DEPARTMENT OF TRANSPORTATION

Contract #: 04-0120F4Cty: SF/ALA Rte: 80 PM: 13.2/13.9File #: 69.28**WELDING INSPECTION REPORT****Resident Engineer:** Pursell, Gary**Address:** 333 Burma Road**City:** Oakland, CA 94607**Report No:** WIR-012390**Date Inspected:** 06-Feb-2010**Project Name:** SAS Superstructure**OSM Arrival Time:** 645**Prime Contractor:** American Bridge/Fluor Enterprises, a JV**OSM Departure Time:** 1845**Contractor:** Zhenhua Port Machinery Company, Ltd (ZPMC), Changxing Island **Location:** Shanghai, China

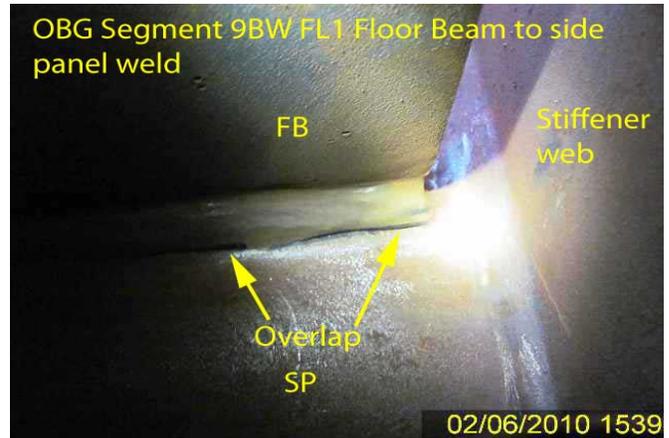
This QA Inspector performed random visual inspection of OBG segment 9BW internal weld surfaces. ZPMC and ABF QA have not visually accepted the above mentioned welds and repairs are still in process. Areas requiring light grinding were marked for ZPMC personnel. The location of areas requiring weld repair were marked on or adjacent the weld. Caltrans QA observed areas to include but not limited to overlap, arc strikes weld spatter and incomplete fusion areas. Please see attached photos below.
